# A FLECK PERFORMANCE BULLETIN

September 27, 1991

## **3900 Soft Water Regeneration**

# 3900 Conversion for Soft Water Regeneration

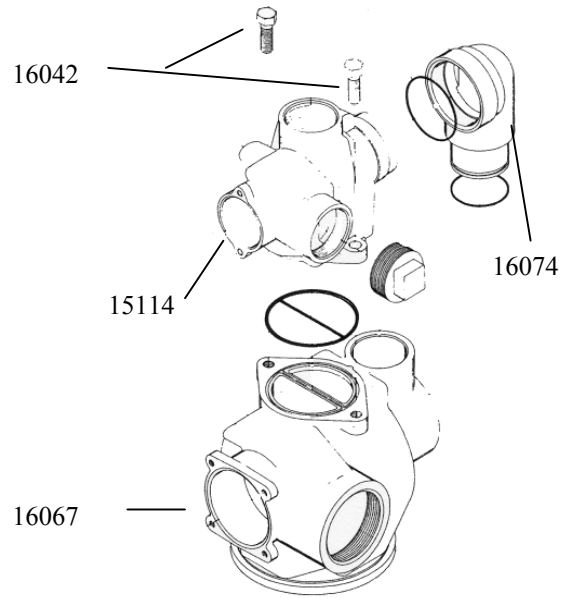
The 3900 control is now available with soft water regeneration. It is recommended that when using the soft water regeneration option, it is ordered with the control. In the event of having to modify a unit, it will be necessary to drill two holes in the lower casting. If you have a 3900 control, which needs the soft water regeneration modification, the next page will show how to modify.

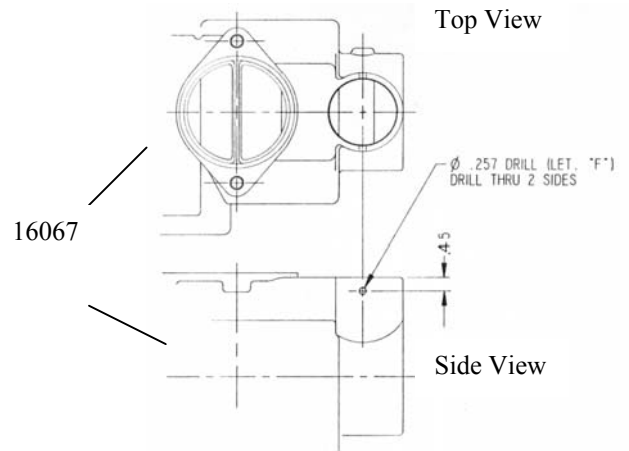
1. Remove upper and lower powerheads.
2. Remove 2-screws (16042), remove the upper valve body (15114) from the lower valve body (16067).
3. Remove coupling (16074).

4. Drill size 0.257 (Letter "F")
5. .45" from top of valve body
6. Before drilling hole, install 17453 sleeve, grease 16077 o-ring, then slide in 17454 plug. This will stop shavings from entering the valve body.

7. Drill holes thru 2 sides of the lower valve body (16067).
8. Insert 17452 shaft thru the drilled holes.
9. Snap 10250 clip to each side of the 17452 shaft.
10. Reinstall upper valve body 15114 and upper/ lower power heads.
11. Raw water to inlet lower valve body (16067).
12. Treated water to inlet upper valve body (15114).
